CITY OF BOULDER
Community Planning & Sustainability

CITY OF BOULDER
LAND USE REVIEW RESULTS AND COMMENTS

DATE OF COMMENTS: **January 23, 2015**
CASE MANAGER: **Chandler Van Schaack**
PROJECT NAME: **THE PLAZA**
LOCATION: **4403 N BROADWAY**
COORDINATES: **N08W07**
REVIEW TYPE: **Site and Use Review**
REVIEW NUMBER: **LUR2011-00071**
APPLICANT: **Jeff Dawson**
DESCRIPTION: **SITE AND USE REVIEW: Revisions to Site & Use Review proposal to construct a mixed-use development including 6 residential duplexes (12 units total), and 3 mixed-use buildings with 16 attached residential units above 9,359 sq. ft. of office and restaurant space.**

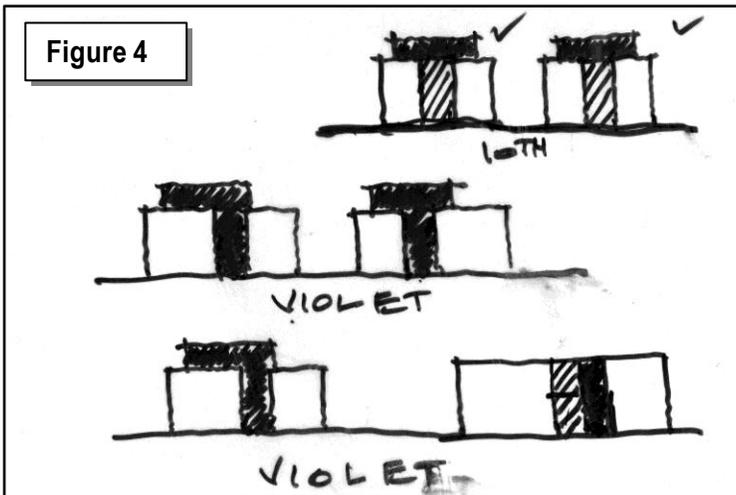
2. Regarding the Violet Ave. frontage, there are similar issues with the visual patterning as those discussed above. Staff also finds that the stucco treatment of the garage areas does not meet section 9-2-14(h)(2)(F)(xii), which requires buildings to “present a sense of permanence through the use of authentic materials such as stone, brick, wood, metal or similar products and building material detailing.” Staff recommends replacing the stucco with brick, and adding

visual interest to the Violet elevations by incorporating brick courses similar to those found on the mixed-use buildings to the east. The south elevation of building C should also be simplified and made more symmetrical in terms of material treatment. The western elevations of duplexes 1 and 2 provide examples of the visual patterning and general symmetry that should be enhanced along the Violet frontage. Please see **Figures 3 & 4** below for highlighted areas of concern and a general sketch representing an example of the desired “visual patterning” discussed above (brick shown in white, wood in black, and stucco in stripes).

RESPONSE: All of the duplex units along Violet Ave have been removed, and replaced with Townhome units that present a sense of permanence by using a majority of brick, masonry, metal, and wood. The Townhome units are designed with a simplicity that creates a strong visual pattern along Violet Avenue. The South elevation of Building C has been simplified by changing stucco areas to brick, therefore creating a continuous datum across the project.

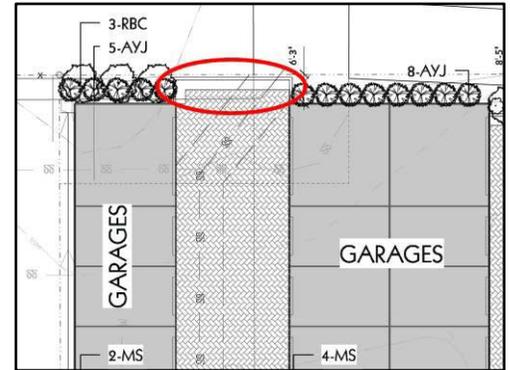
2. The north end of the western garage drive aisle (see the image to the right) continues to show that a modification to property line screening is required. If a fence or alternative method can be used to functionally screen the parking lot, please do so. Please call this modification out in the Requirements Table.

RESPONSE: Please see revised plan and Schematic Architectural Sketches Sheet showing the addition of new fence at end of drive aisle.
